Re: Docket No. 20230023-GU; Petition for Rate Increase by Peoples Gas System, Inc.

Docket No. 20220212-GU; Peoples Gas System, Inc.'s Petition for Approval of Depreciation Rate and Subaccount for Renewable Natural Gas Facilities Leased to Others

**PEOPLES GAS SYSTEM, INC.
DOCKET NO. 20220212-GU
DOCKET NO. 20230023-GU
STAFF'S FOURTH DATA REQUEST
REQUEST NO. 1
BATES PAGE(S): 1
FILED: APRIL 21, 2023**

(BARN #3 AND #4)

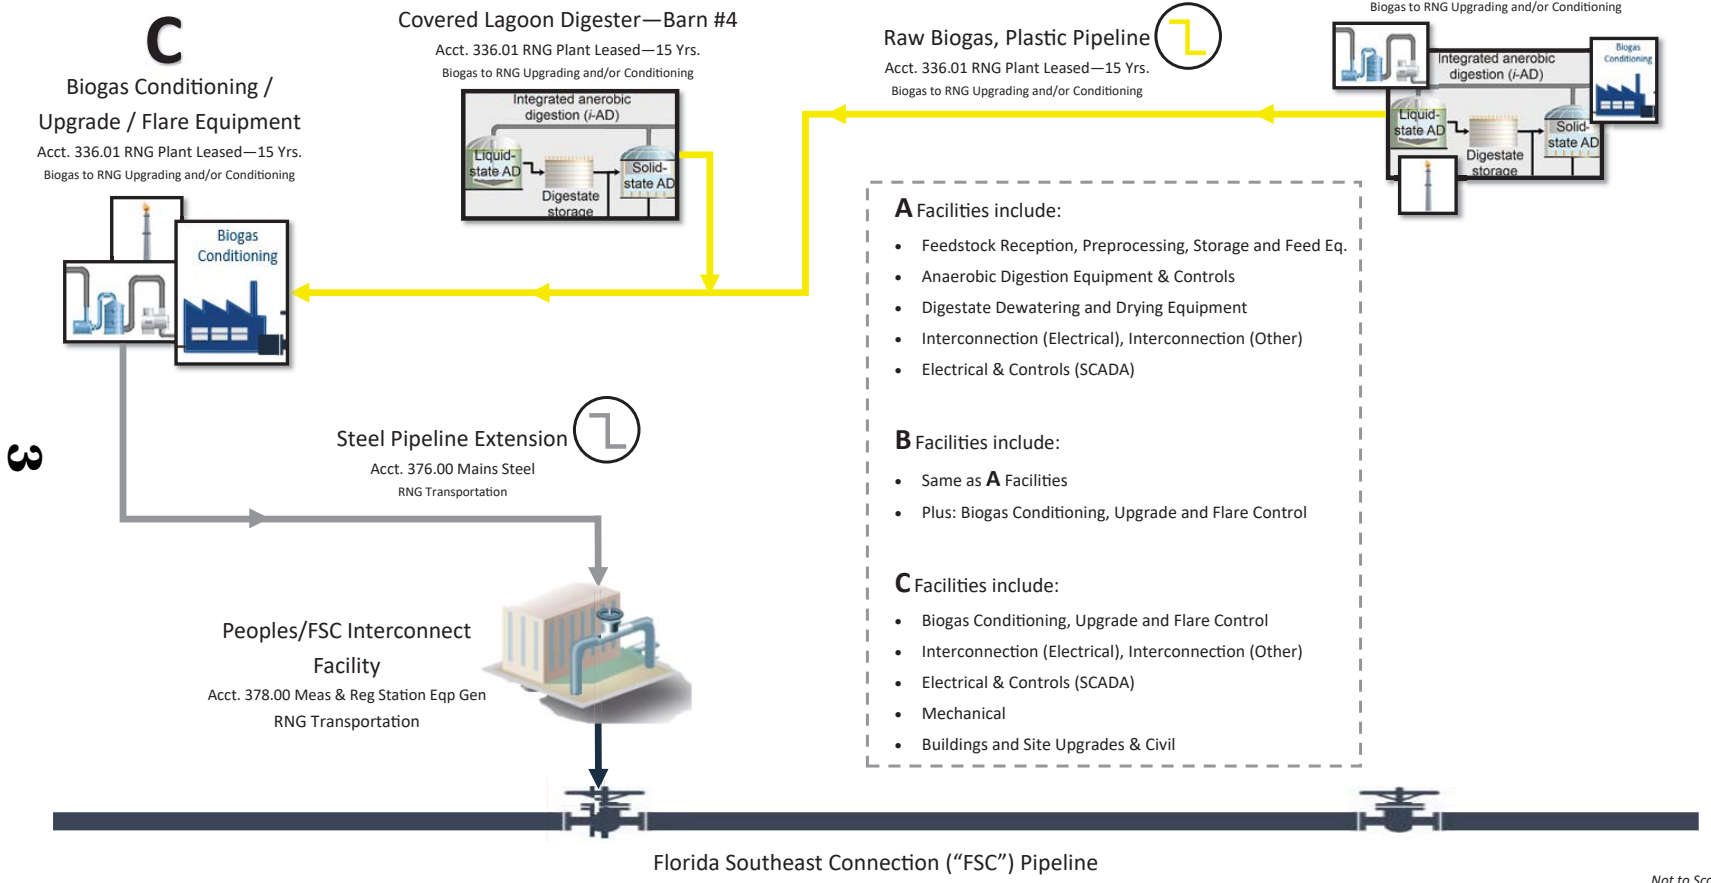
- 2.** Please provide a flow chart depicting the anticipated process of biogas production, RNG conditioning, and transportation for the Project and the associated facilities. As part of this response, please identify each facility associated with each process step and the associated accounts.

- A.** See attached diagrams provided for the Brightmark Project located in files “Staffs 4th DR No 2 Brightmark Barns 3 & 4 Diagram.pdf” and “Staffs 4th DR No 2 Brightmark Barns 5 & 8 Diagram.pdf”.

- A** Facilities include:
- Feedstock Reception, Preprocessing, Storage and Feed Eq.
 - Anaerobic Digestion Equipment & Controls
 - Digestate Dewatering and Drying Equipment
 - Interconnection (Electrical), Interconnection (Other)
 - Electrical & Controls (SCADA)
- B** Facilities include:
- Same as **A** Facilities
 - Plus: Biogas Conditioning, Upgrade and Flare Control
- C** Facilities include:
- Biogas Conditioning, Upgrade and Flare Control
 - Interconnection (Electrical), Interconnection (Other)
 - Electrical & Controls (SCADA)
 - Mechanical
 - Buildings and Site Upgrades & Civil
